Non-Concurrence Process Record for NCP-2012-001

TITLE OF SUBJECT DOCUMENT DIABLO CANYON POWER PLANT - INSPECTION REPORT 05000275/323-2011005		ADAMS ACCESSION NO. <i>ML 120450843</i>
DOCUMENT SIGNER Neil O'Keefe,		SIGNER PHONE NO. (817) 200-1141
TITLE Chief	ORGANIZATION Project Branch B, Region IV	
NAME OF NON-CONCURRING INDIVIDUAL(S) Michael Peck		PHONE NO. (805) 595-2354
TITLE Senior Resident Inspector	ORGANIZATION Project Branch B, Region IV

Figure 1
Comparison of DE, DDE, & HE Horizontal Response Spectrum at the Steam Generators

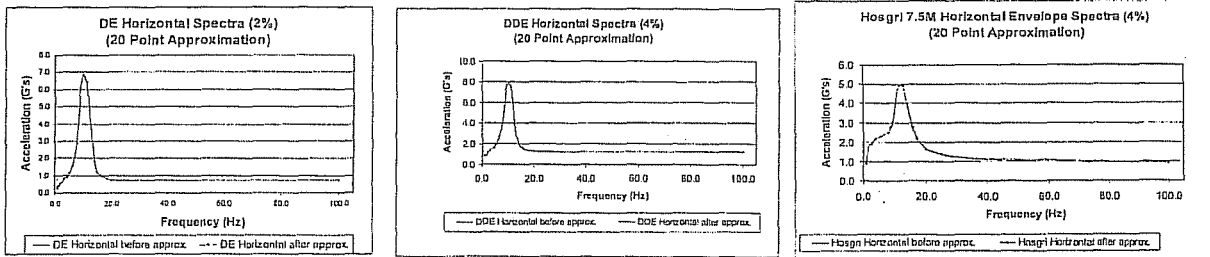
The HE represented the largest ground motion of the three design basis events. However, SSC seismic qualification was limited by each of the three design basis earthquakes. For example, the safety analysis predicted higher vibratory motion for DE and DDE than the HE at the steam generators, as shown in Figure 1. The bounding vibratory motion (shaking), used to seismically qualify individual plant components, was a function of the component location. As shown in Figure 2, the DDE provided the limiting floor response spectrum for the 88 foot level of the containment building. The seismic qualification of plant structures was also limited by both the DDE and HE, dependant on location. For example, the seismic qualification of the lower levels of the containment structure were limited by the HE design basis while the upper levels were dominated by the larger DDE spectrum. Portions of the reactor coolant pressure boundary were more limited by the DE and DDE than HE. These differences in qualification requirements resulted from different assumptions, methods, design basis values/inputs, and acceptance criteria approved for each seismic safety analysis.

The licensee's substitution of the HE design basis for demonstrating the DDE Code acceptance criteria were met was not an acceptance approach by either the licensee's operability procedure or the NRC operability guidance. This was a concern because in many cases, the reactor coolant pressure boundary stress was more limiting for the DDE than HE (see Figure 1).

Figure 2
Comparison of DDE and HE Containments Floor Response at 88 Foot

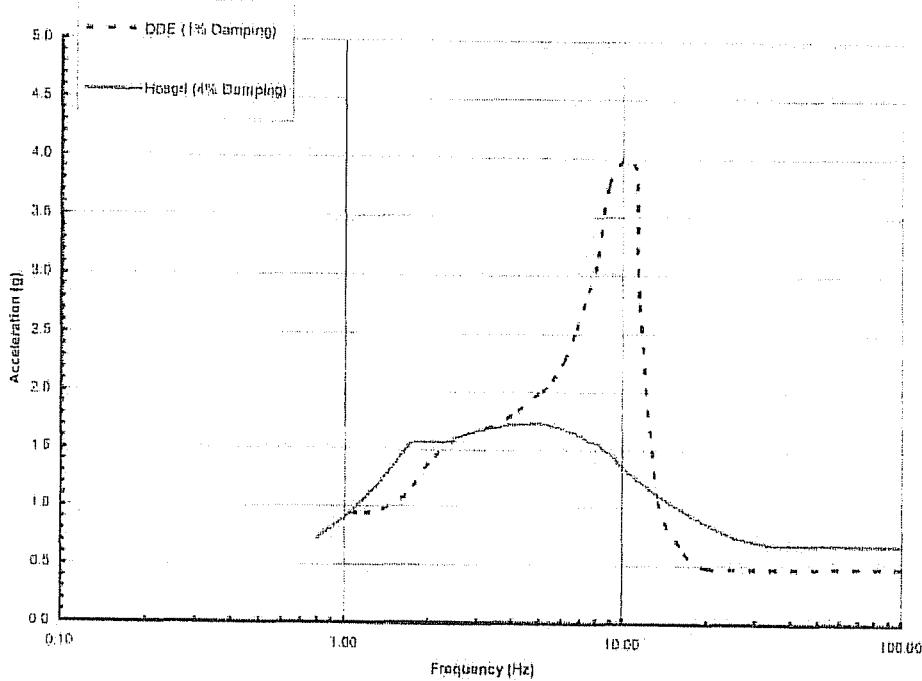
In many cases the DDE safety analysis provided the bounding vibratory motion used to establish the seismic qualification for plant SSC. For example, the FSARU credited the containment fan coolers to mitigate the design basis loss of coolant and steam line break accidents. The design basis required these coolers to be qualified to function following the vibratory motion (shaking) associated with the DDE. These coolers are located on the 88 foot level of the containment building. As shown in Figure 2, the DDE vibratory motion was greater than HE at this location. The POD was inadequate because the licensee failed to

demonstrate that the coolers would still function at the increased motion associated with the new seismic information for the DDE case.
